Date: 2/14/08
To: All Contractors/Vendors
From: Linda M. Martin, Clerk
Subject: Addendum Number: 3
Project Name: Eddy Street Commons Phase II Parking Garage
Project Number: 108-004

ADDENDUM # 3

PROJECT: Eddy Street Commons Phase II Parking Garage
1200 Edison Road
South Bend, Indiana

**Addendum No. 3
February 14, 2008**

Reference Drawing: E101

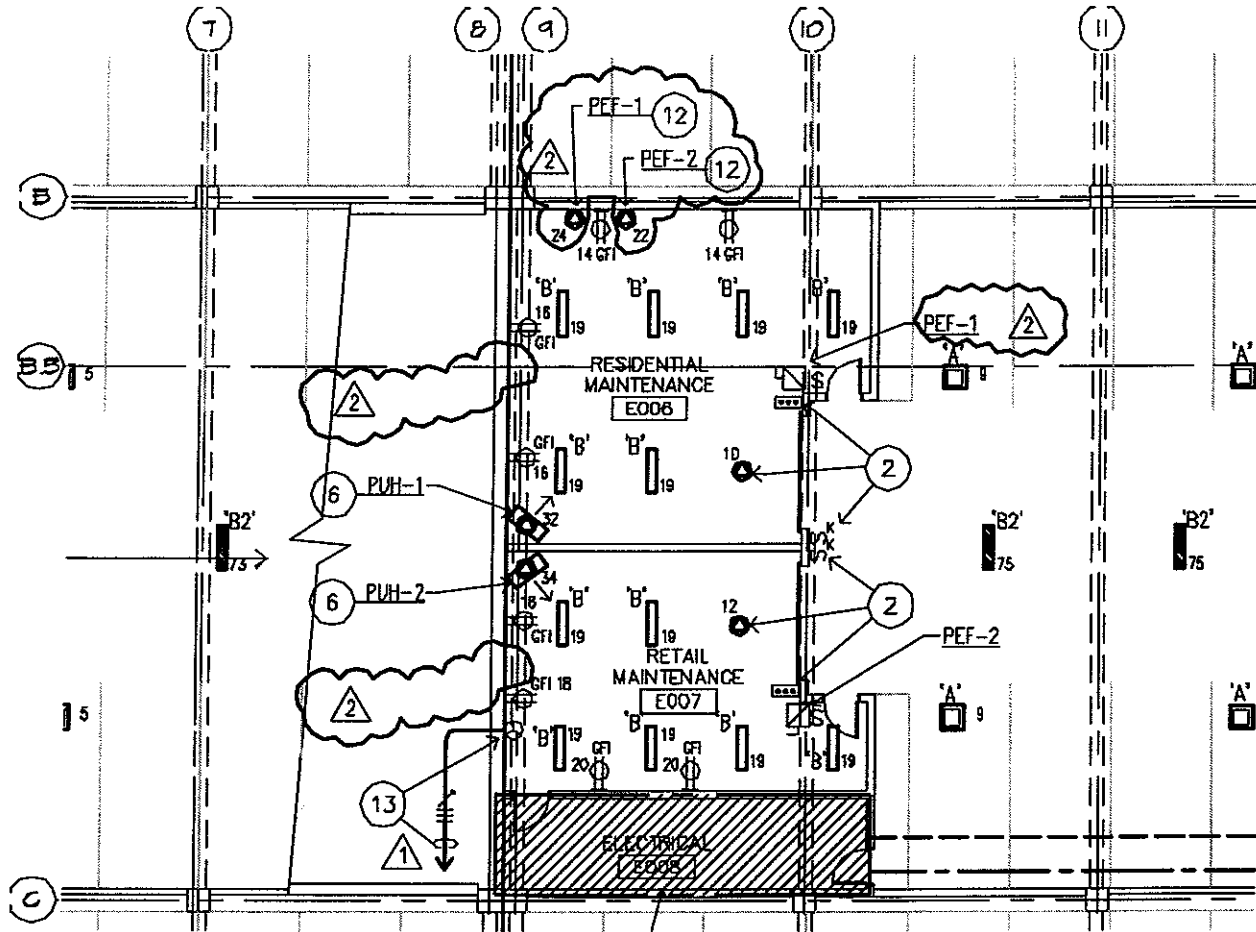
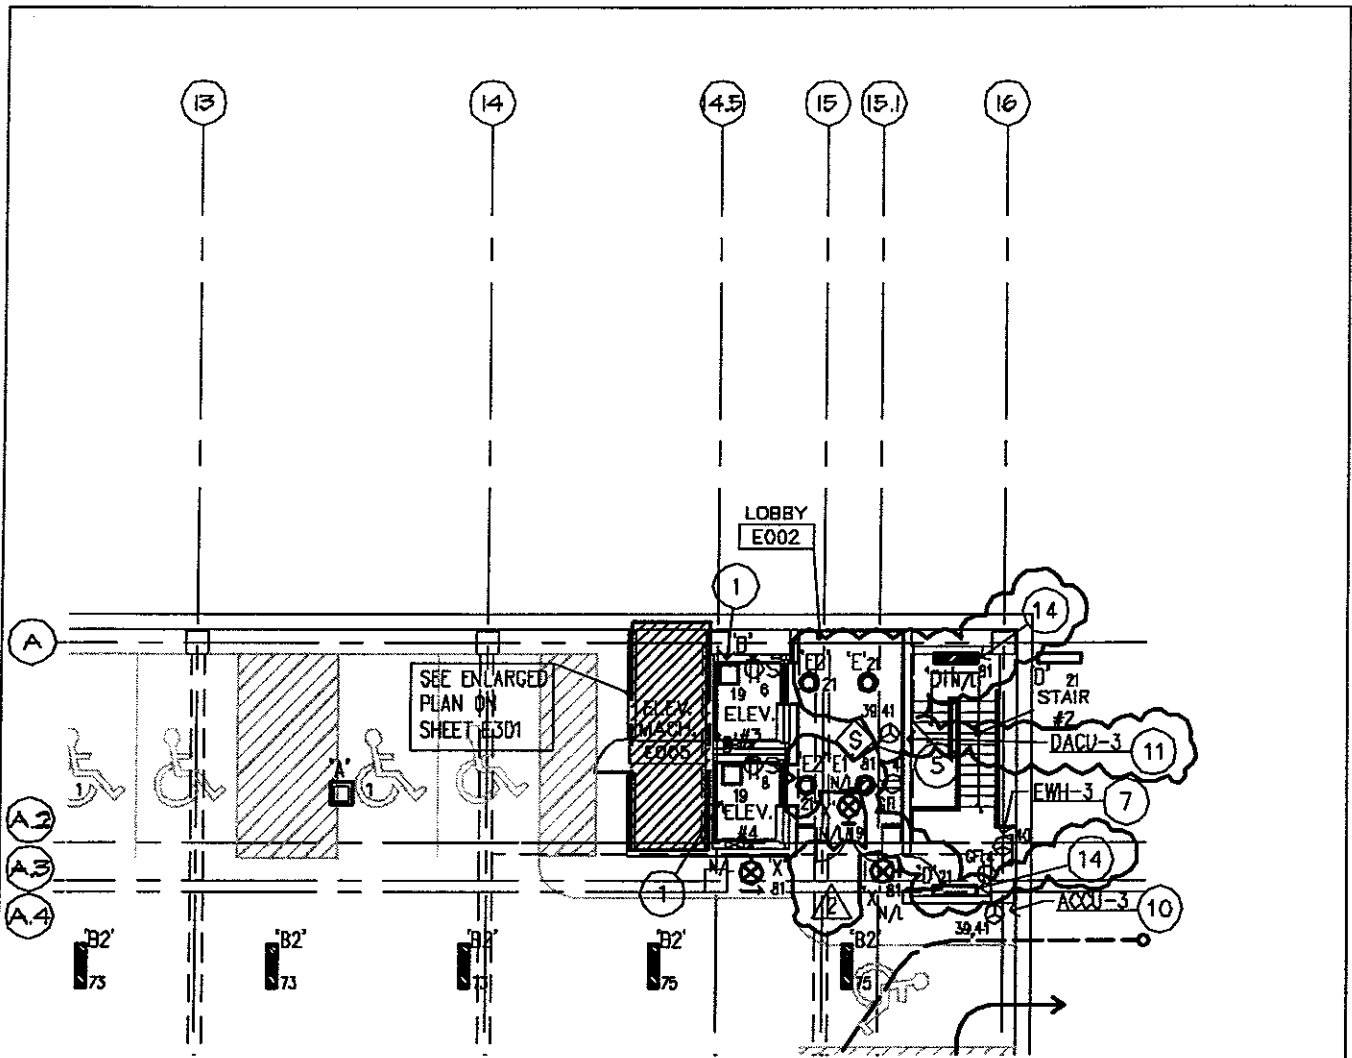
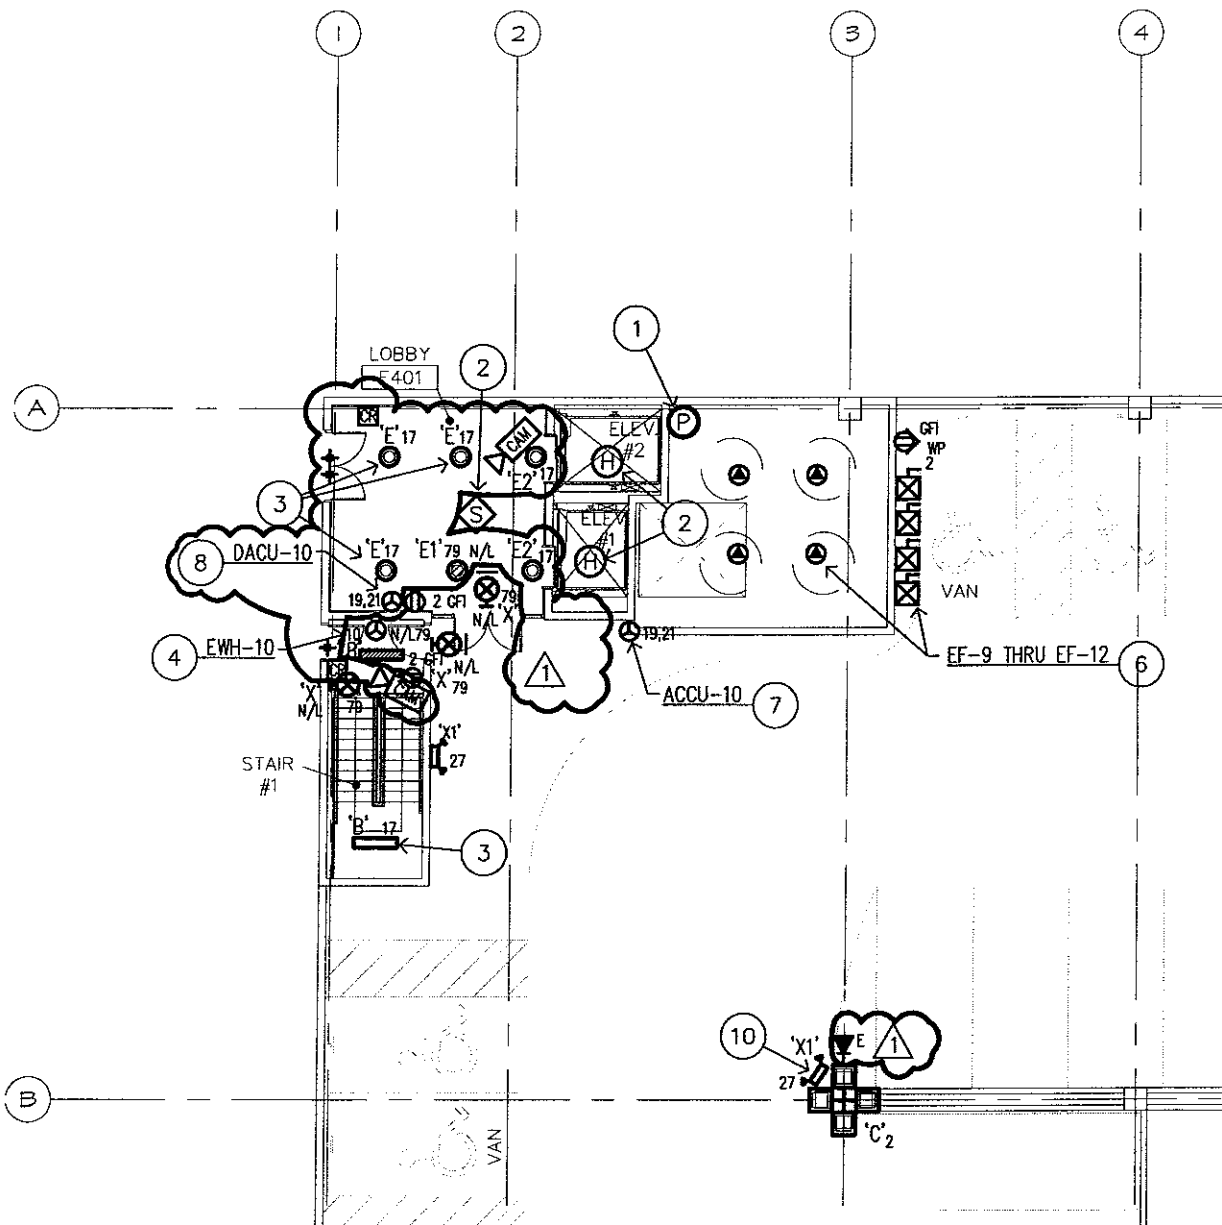
1. Change lighting in elevator lobbies and northeast stair and revise mechanical equipment locations. See attached Sketches E-SK003, E-SK004, E-SK-005.

Reference Drawing: E105

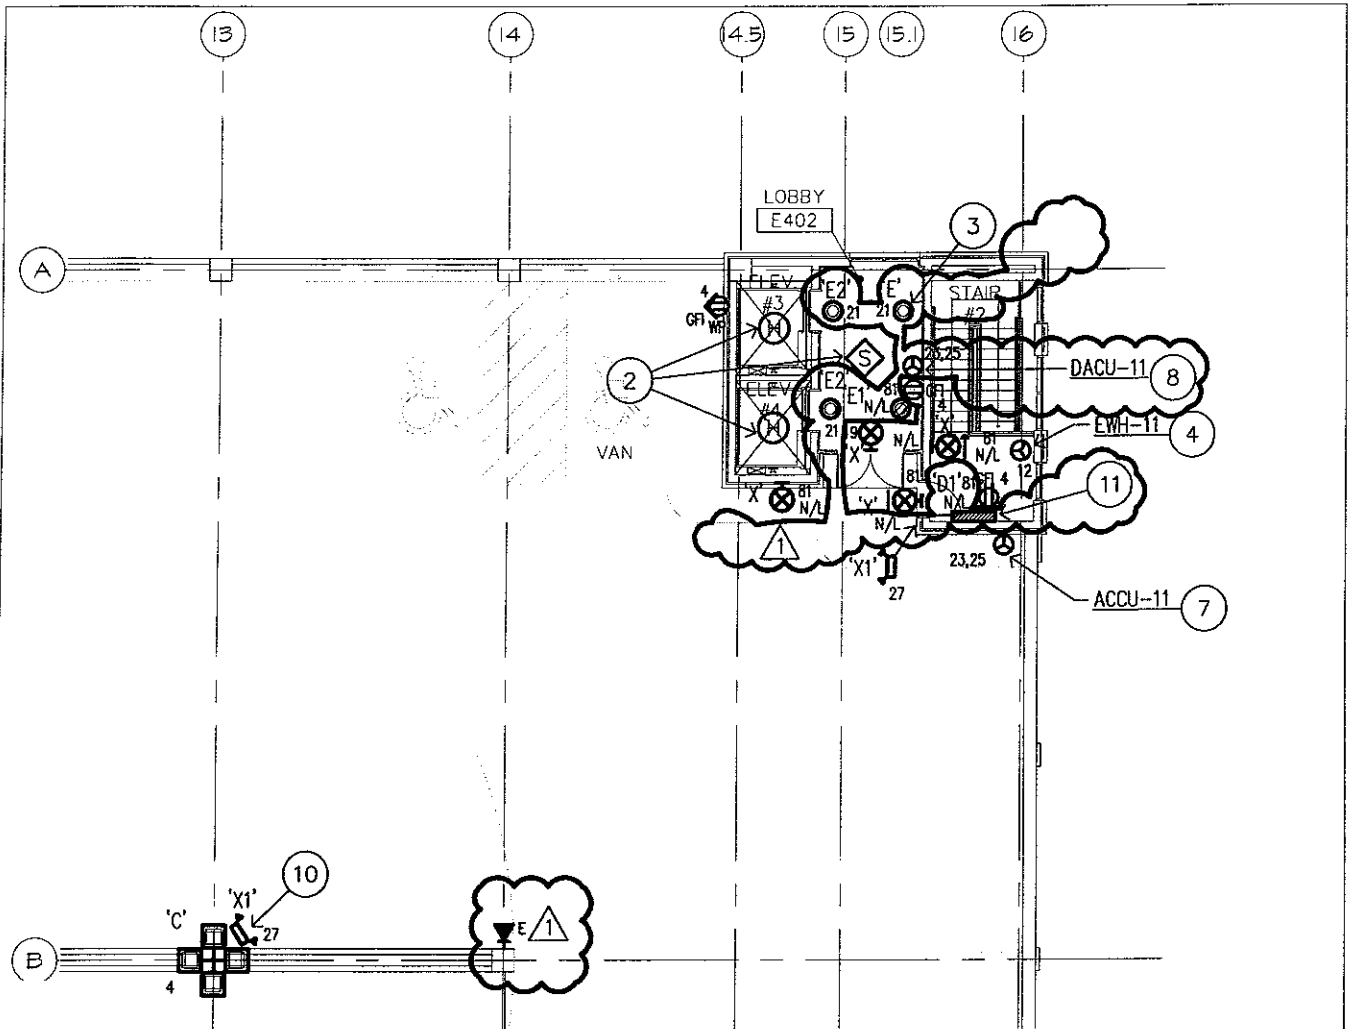
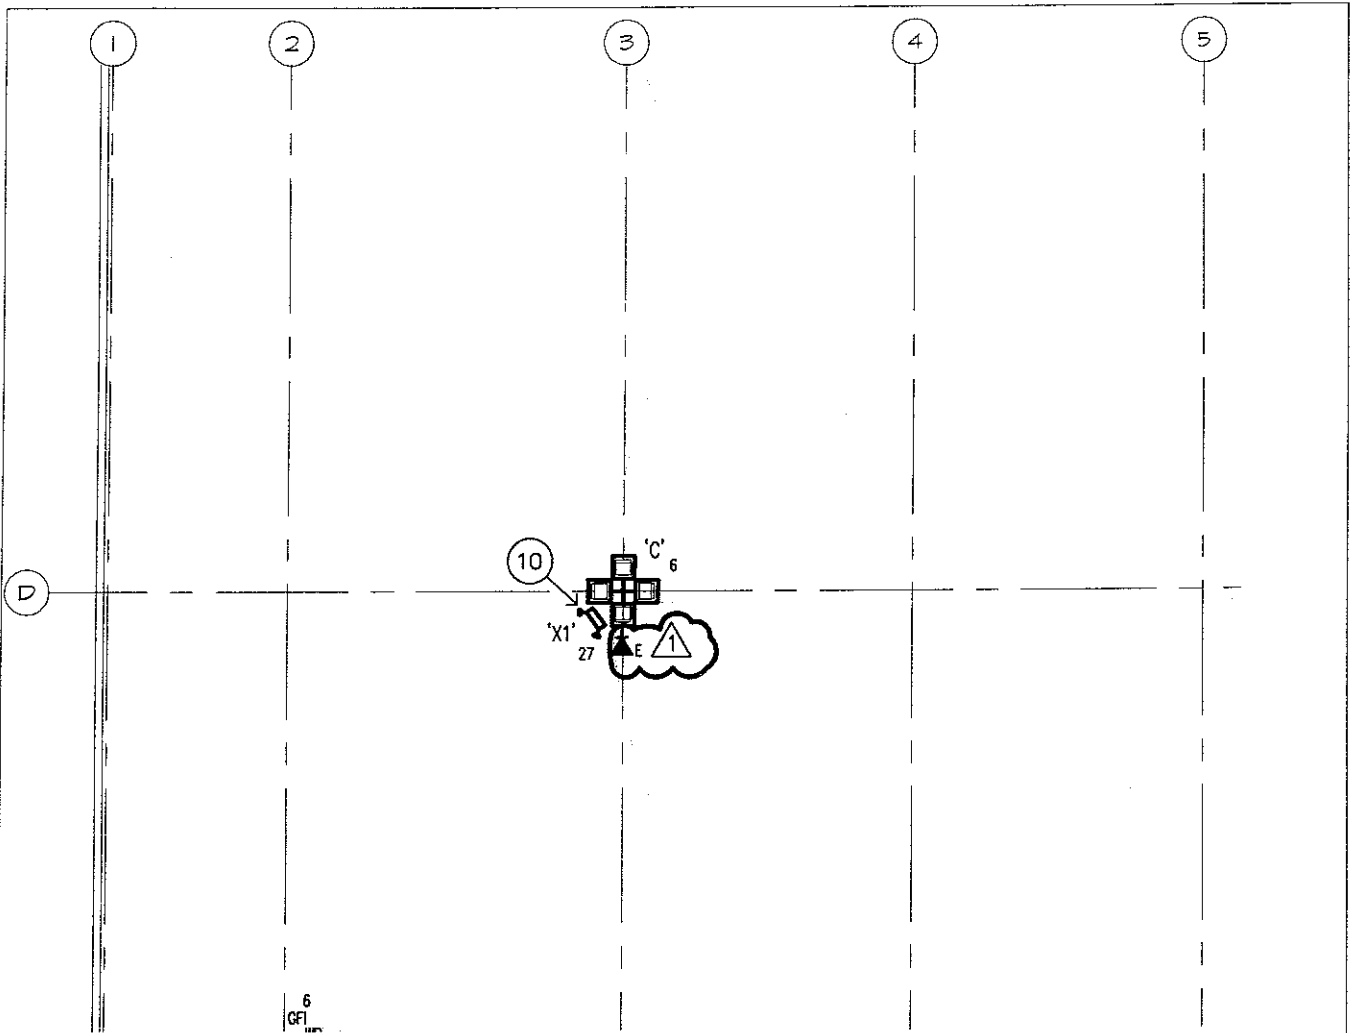
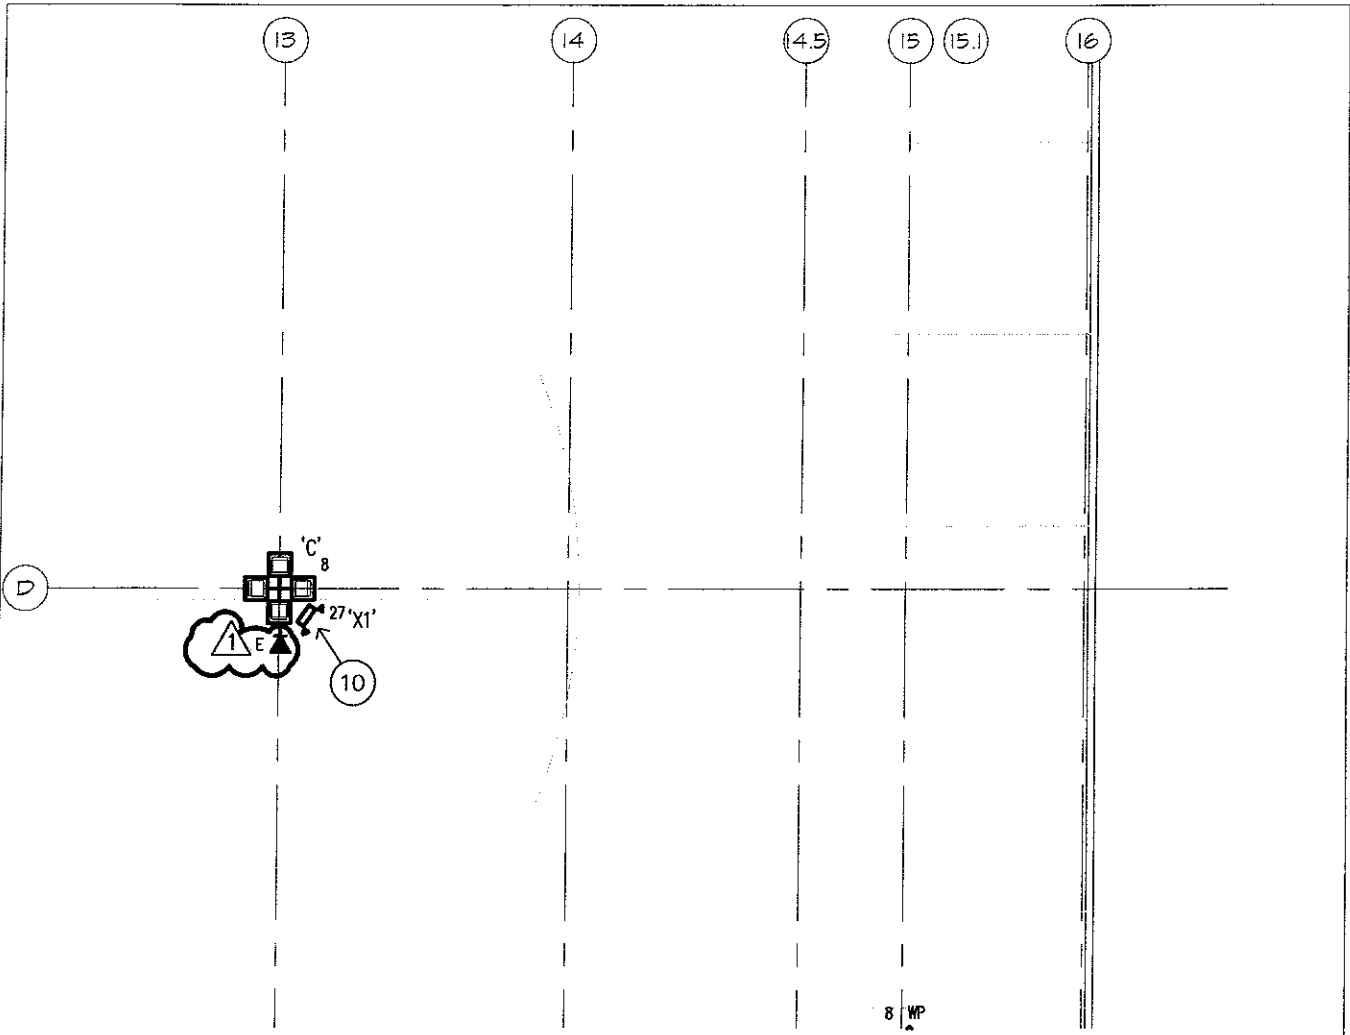
1. Change lighting in elevator lobbies and northeast stair. Also add security rough-ins. See attached Sketches E-SK006, E-SK007, E-SK008, and E-SK009.
2. Provide capacitor in NEMA 3R rated enclosure with NEMA 3R 150 amp disconnect switch, installed ahead of capacitor and starter for EF-1 through EF-12.

Reference Drawing: E301
Revision Number: **1**
Drawn by: APO Checked by: JLW
Project No.: 108-004 Scale: 1/4" = 1'-0"
Drawing No.:

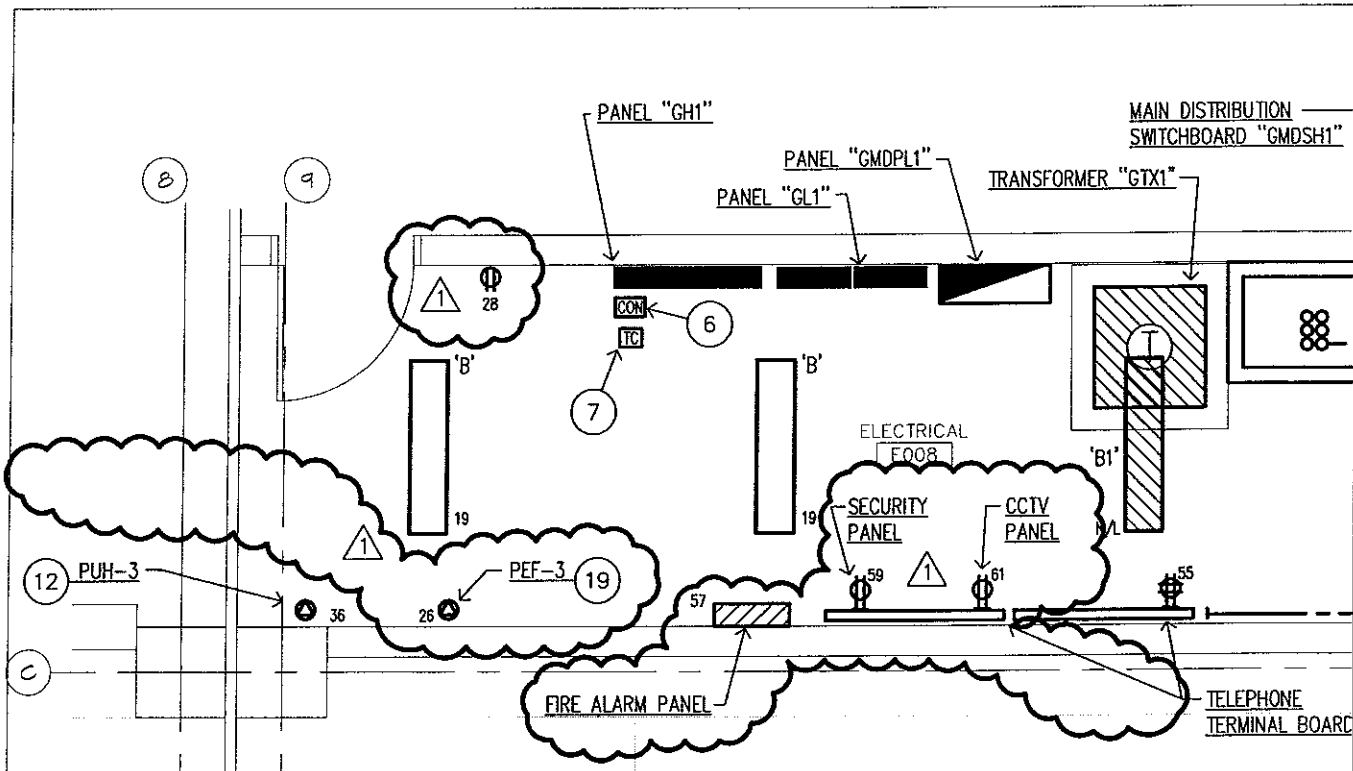
1. Add another equipment terminal board, receptacles and adjust mechanical equipment connection location. See attached Sketch E-SK010.
2. Provide capacitors and install between fuse switch and elevator equipment.
